CPED STAFF REPORT

CPC Agenda Item #9
 April 13, 2015
 BZZ-7012

Property Location: 701 7th Street North & 618 7th Avenue North
Project Name: The Lock Up Self Storage
Prepared By: [Becca Farrar-Hughes](#), Senior City Planner, (612) 673-3594
Applicant: Lock Up Minneapolis 701, LLC
Project Contact: Beck Law Office, Attn: Peter Beck
Request: To allow a new 4-story self-service storage facility.
Required Applications:

BUILDING ELEVATIONS

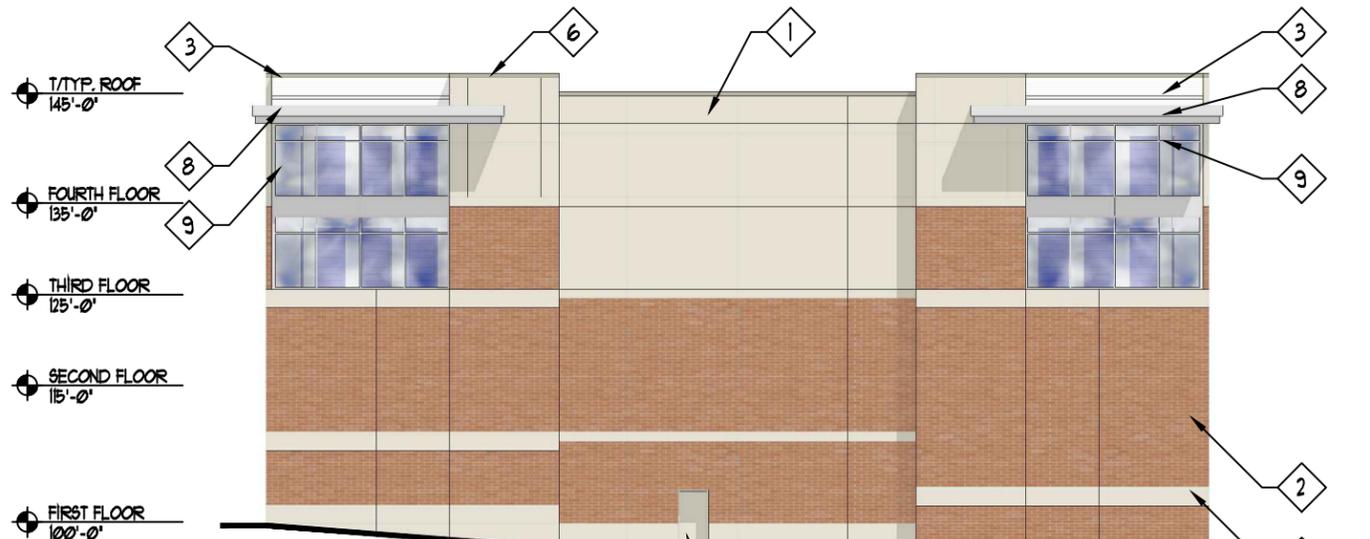
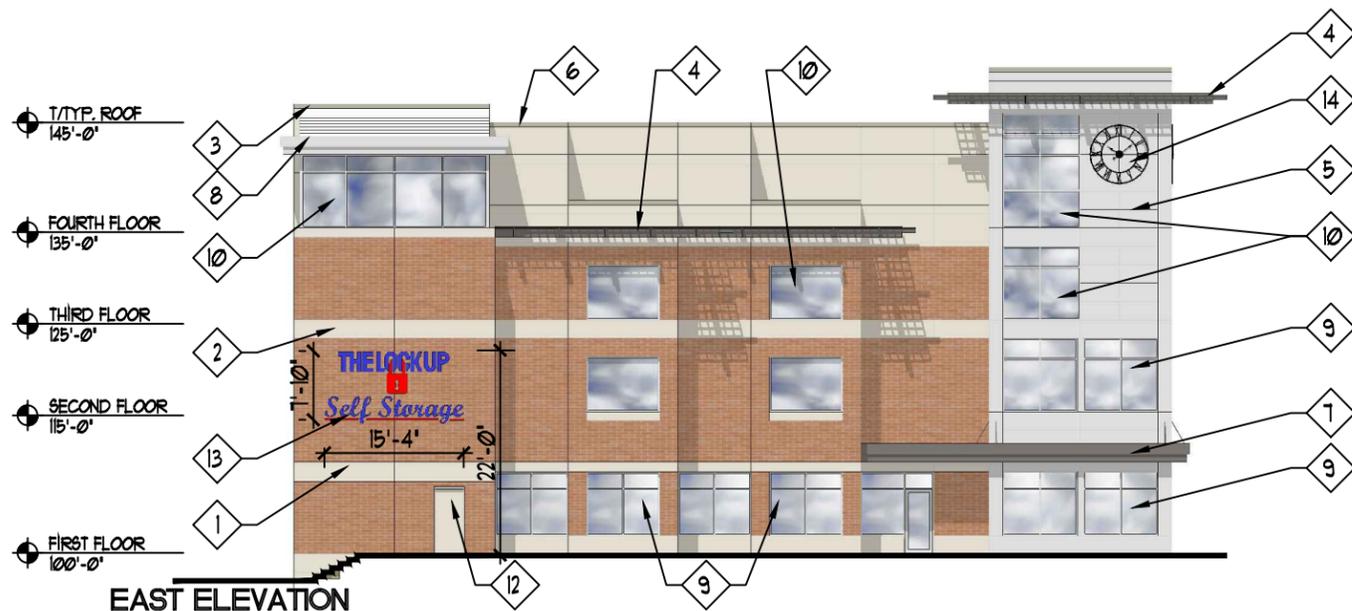
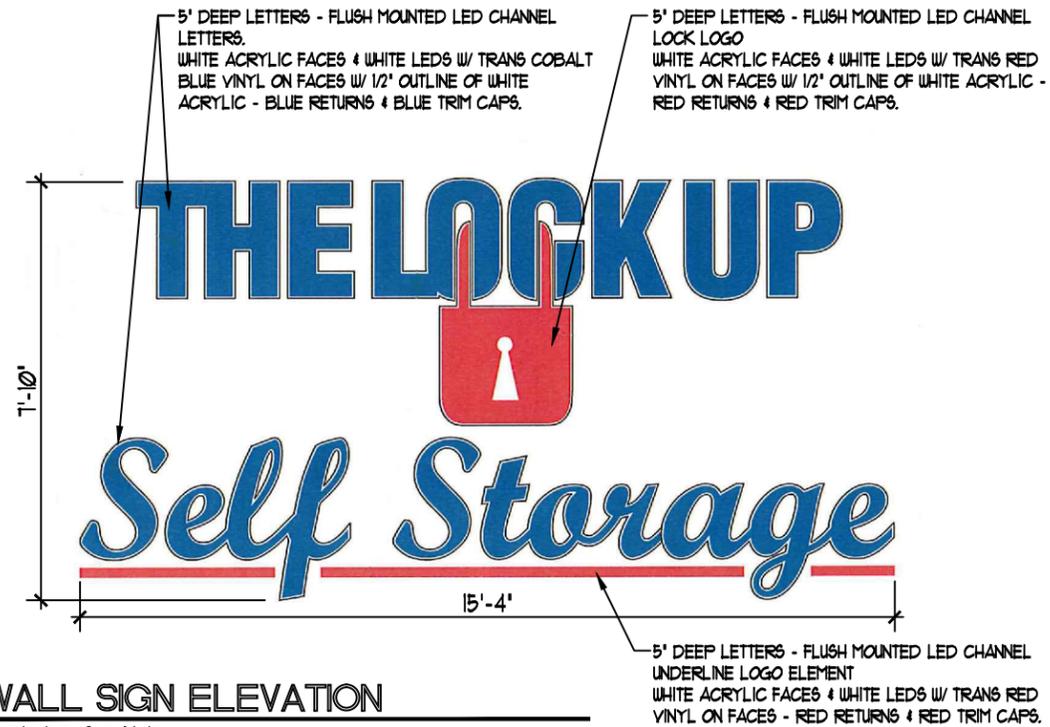
- **30% window requirement.** The south elevation of the proposed structure is not meeting the window requirement as 30% are required and 0% is being provided. This is due to the fact that the applicant is proposing clear glass that looks into display windows, which does not meet the requirements of the site plan review ordinance. Ground-floor windows facing the street must allow views into and out of the building. Shelving or other fixtures cannot block such views. Display windows do not allow views into and out of a building. Alternative compliance is necessary. Staff would recommend that the Planning Commission require compliance as it would be practical to include windows that meet the 30% window requirement on this elevation especially given that much of the north elevation and the west elevation are exempt from the window requirements. For example, the floor plan could be modified to include a corridor along the entire length of the elevation where intermittent activity (customers accessing units, custodial and office workers, etc.) would occur. Further, this is a 218 foot long building wall adjacent to a public street and public sidewalk with no windows that allow views into the building.

- **10% window requirement.** Regarding the floors above the first floor of the building (floors 2 through 4), there are some floors on each elevation that exceed the 10% requirement and others that do not, specifically on the north and west elevations of the building. The windows are even in their distribution and vertical in their proportion. Alternative compliance would be necessary for the 10% window requirement. Staff would recommend that the Planning Commission require compliance with the provision on all elevations, floors 2-4, as applicable in order to provide breaks in the massing that is provided on the exterior building walls.

7. The building shall be modified to comply with the 10% window requirement on all elevations, floors 2-4, as applicable per Section 530.120 of the Zoning Code.

Sheet Title
SITE PLAN

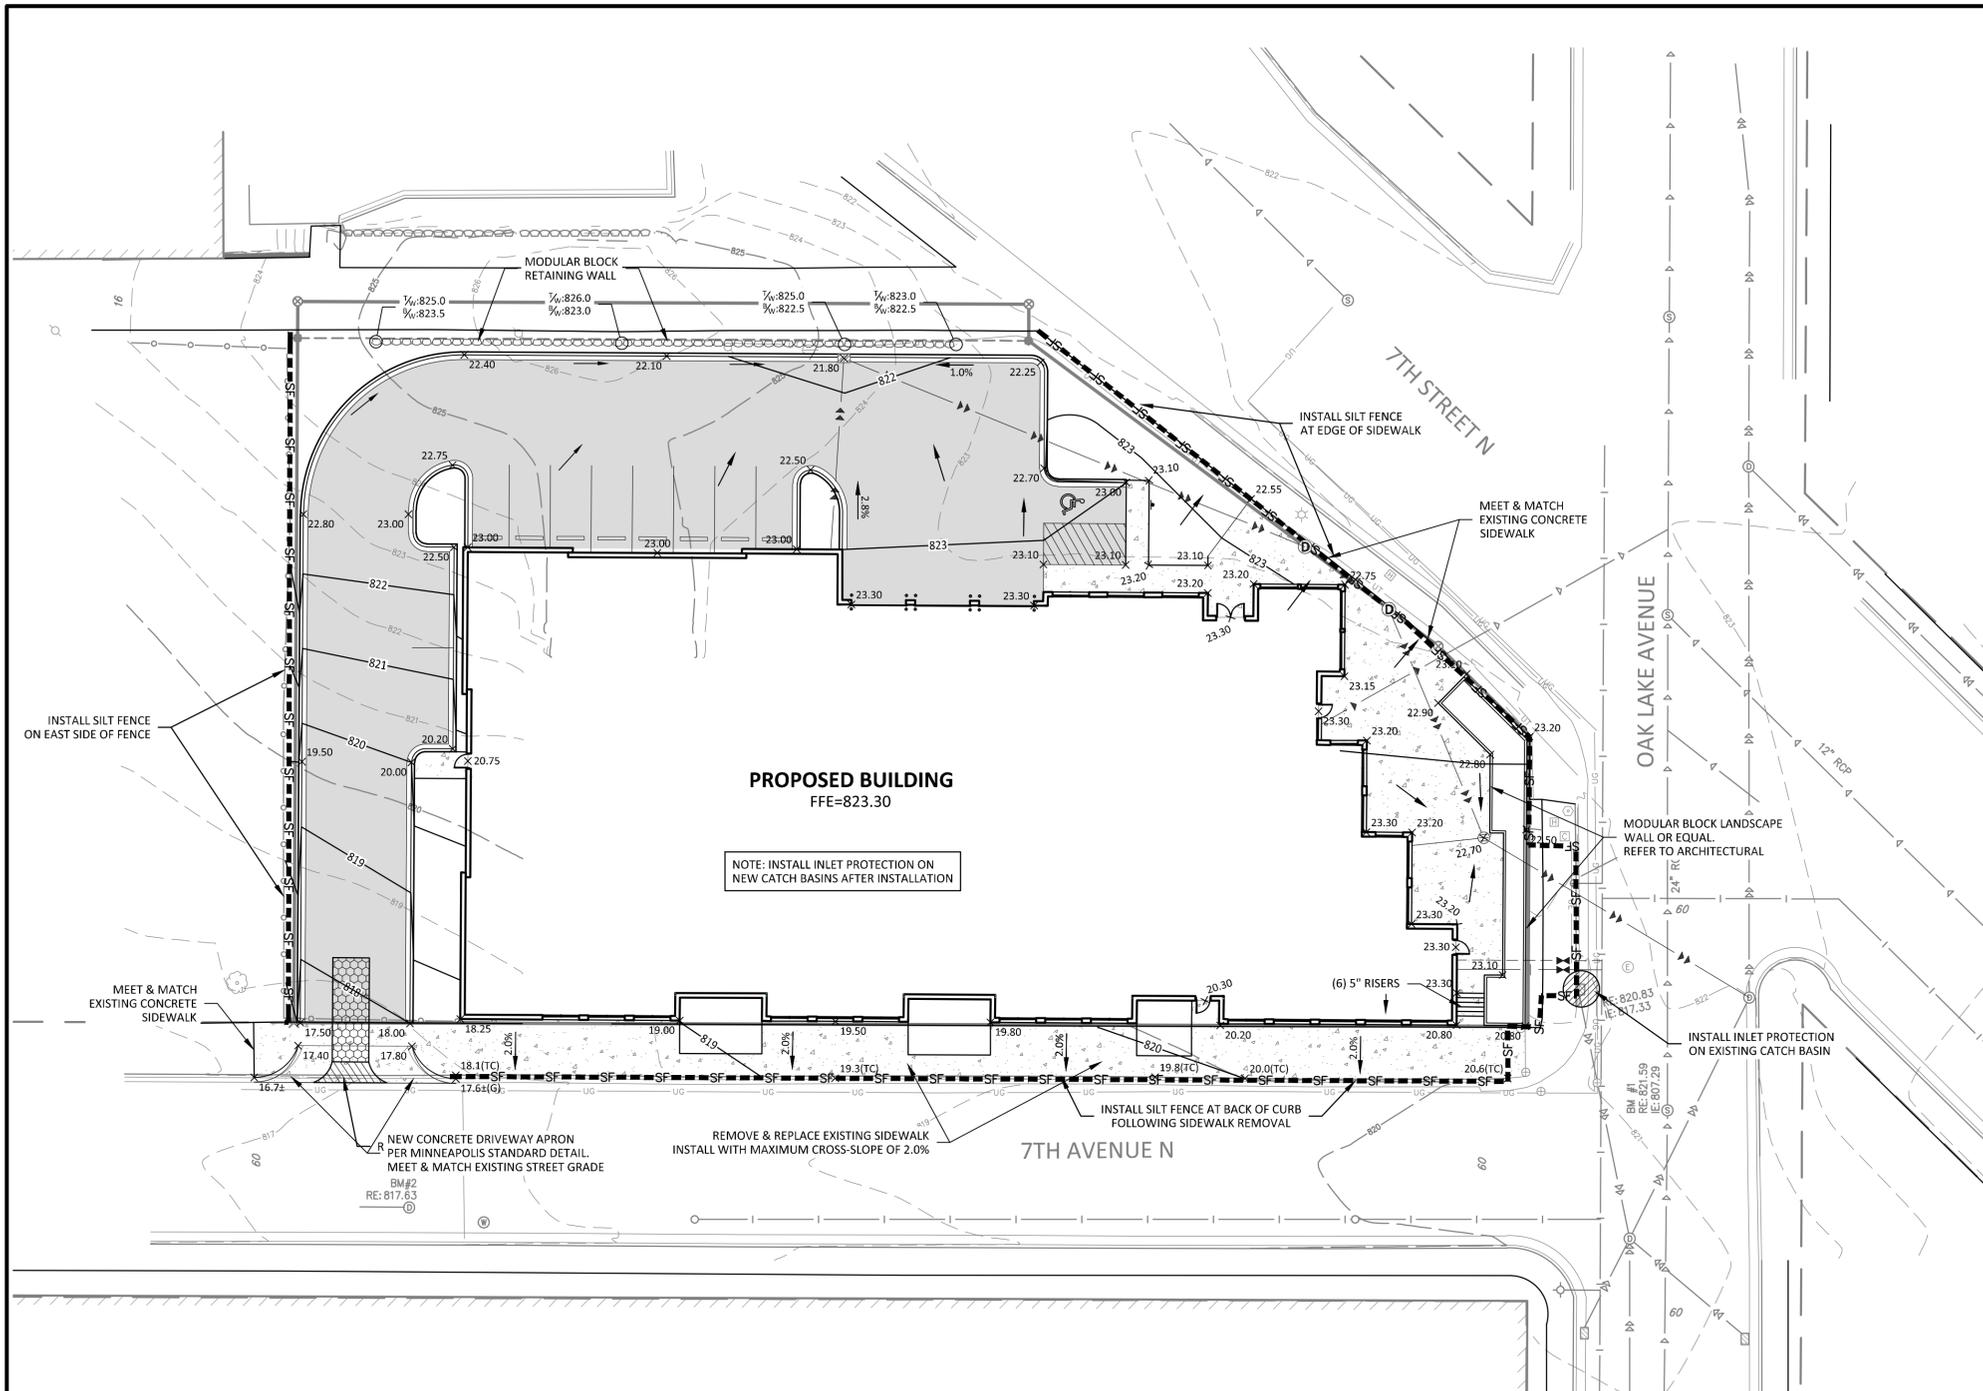
- The site plan indicates proposed access for erosion control purposes to the vacated alley right-of-way and private property along the north property line. Unless the Applicant can provide documentation that the adjacent property Owner has allowed access; vehicular access across a third parties property cannot be approved and will not be allowed at this location.

- Stormwater Management: Please identify the square footage of the existing impervious area in the Development Summary on Sheet C2.0.
- Please note, the stormwater treatment manhole may not be eligible for a Stormwater Utility Fee Quality Credit. If interested in obtaining this credit please contact Stormwater Utility Administration for further assistance or questions, 612-673-2965.

1
L1.01 LANDSCAPE PLAN
1"=20'

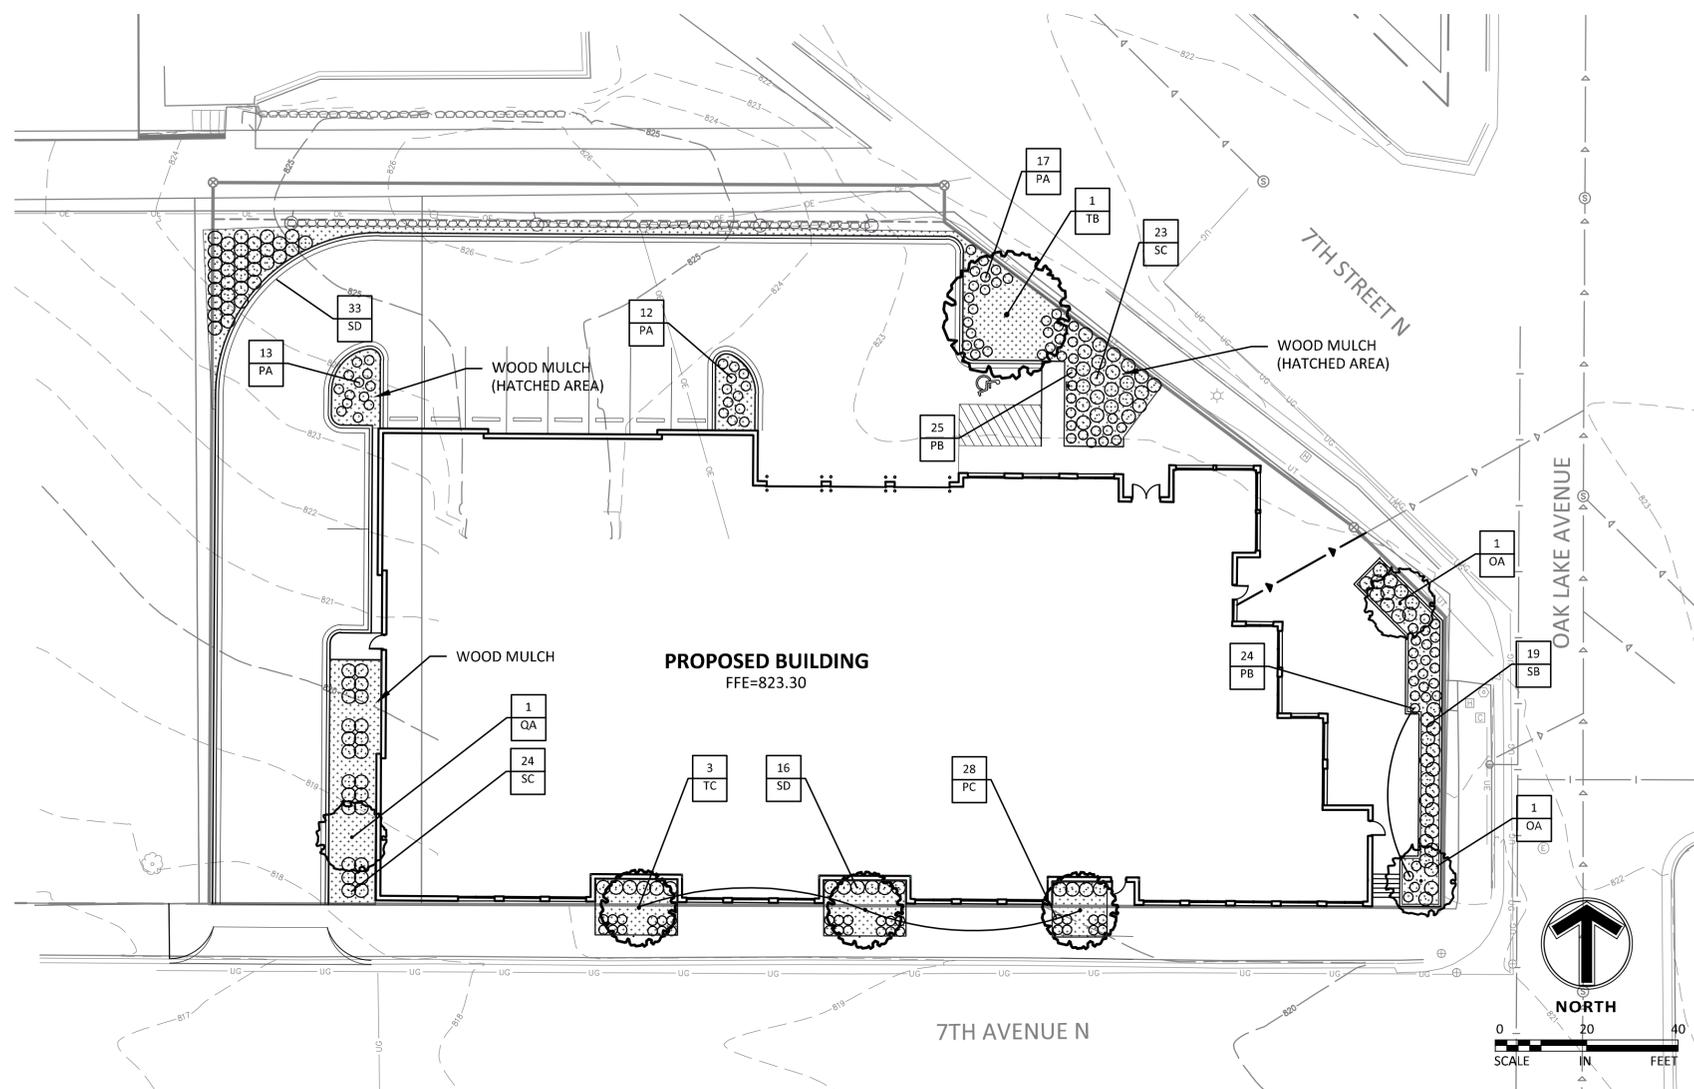
- **20% landscaping requirement.** The Zoning Code requires that at least 20 percent of the site not occupied by buildings be landscaped. The total site area is 37,088 square feet. The proposed building footprint is 19,325 square feet. A total of 3,553 square feet of landscaping would be necessary to meet the 20 percent requirement. The applicant is providing 3,250 square feet of landscaping, or 18% of the area not covered by buildings. Alternative compliance would be necessary. Staff would recommend that the Planning Commission require compliance with this provision as it would be practical to landscape the area to the north of the parking lot. This area is currently being used to access the adjacent property which will no longer be permitted. This approximate 8 foot area is not being landscaped.

- **Landscape quantities.** The Zoning Code requires that at least 7 canopy trees and 36 shrubs be provided. The applicant is proposing to install 4 canopy trees and 3 ornamental trees in addition to 115 shrubs. Alternative compliance would be necessary for the number of trees. Staff would recommend that the Planning Commission require compliance with the provision that requires 7 canopy trees as there are locations that are devoid of trees on the property. Further, Staff would recommend that the Planning Commission require that the applicant provide a combination of deciduous and evergreen shrubs on the property in order to provide a mix of plantings.

- **Proximity to on-site deciduous tree.** The surface parking lot consists of 11 spaces. Of the 11 parking spaces, 9 of these spaces within the surface parking lot are more than 50 feet from an on-site deciduous tree. Alternative compliance is necessary. Staff would recommend that the Planning Commission require compliance with this provision as it would be practical to plant trees in the applicable landscape areas to meet this requirement.

- **Areas not covered by buildings, etc.** There are areas not occupied by buildings, etc., that are not covered by landscaping. Specifically in the area to the north of the parking lot. This area is currently being used to access the adjacent property which will no longer be permitted. This approximate 8 foot area is not being landscaped. Alternative compliance would be necessary. Staff would recommend that the Planning Commission require that this area be landscaped.

10. The final landscape plan shall be modified to comply with the 20% landscape requirement by removing asphalt and incorporating landscaping adjacent to the north property line in the area of the previously vacated alley.

11. The final landscape plan shall be modified to incorporate the required quantities, to comply with the proximity of parking spaces to on-site deciduous trees and to include a combination of deciduous and evergreen shrubs on the property in order to provide a mix of plantings as required by Section 530.160 and 530.170 of the Zoning Code.
